PLANNING, ZONING, & BUILDING DEPARTMENT
PZ&B Staff Memorandum: Architectural Commission

SUBJECT: ARC-24-0040 (ZON-25-0002) 1285 N OCEAN BLVD (COMBO)

MEETING: FEBRUARY 26, 2025, ARCOM
APRIL 9, 2025, TC

South Elevation Previous Proposal /Current Proposal

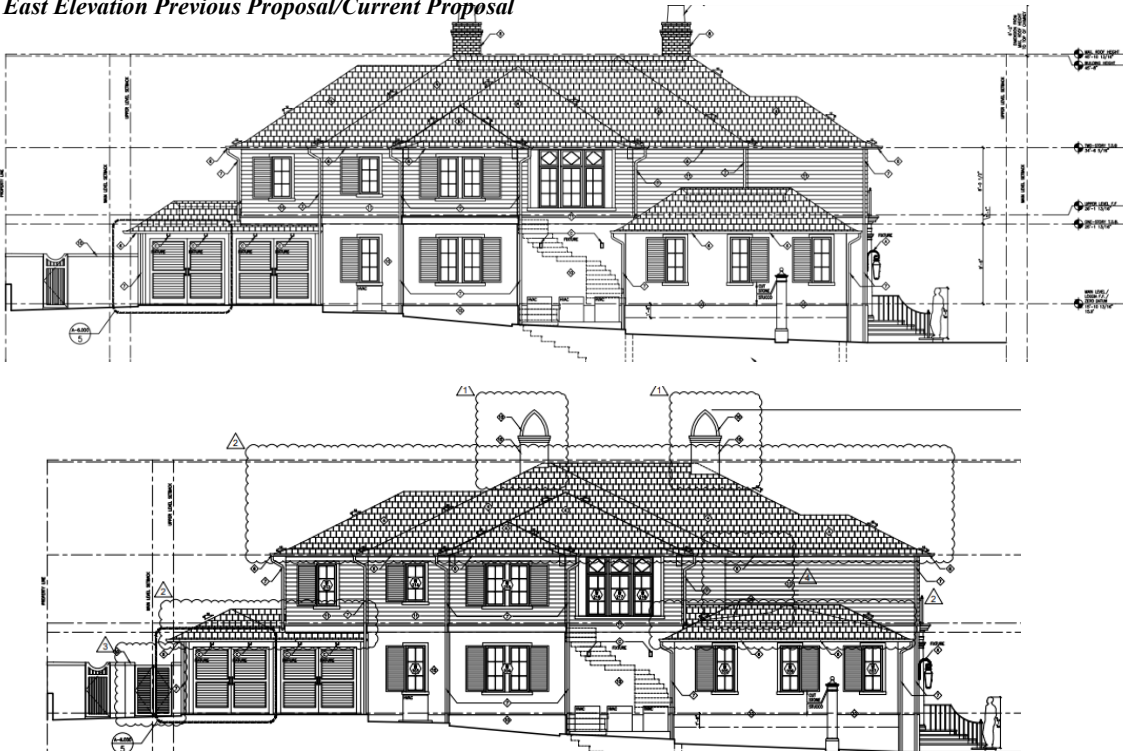
This project was first and last heard on October 23, 2024, by ARCOM requesting minor design changes. The roof massing, chimney designs and driveway has been addressed. Through further study some fill concerns were identified that will require a variance.

East Elevation Previous Proposal/Current Proposal

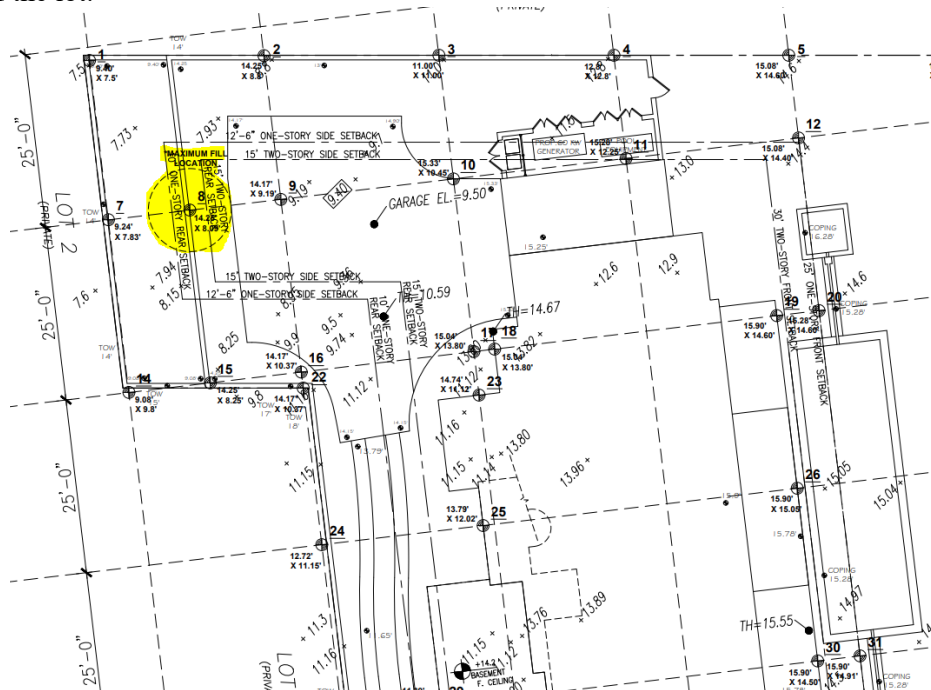
Due to the significant grade change along Kenlyn Road the applicant is wishing to bring in some fill and has one area where it would exceed the permitted fill by approximately 9" at the northwest corner of the lot.
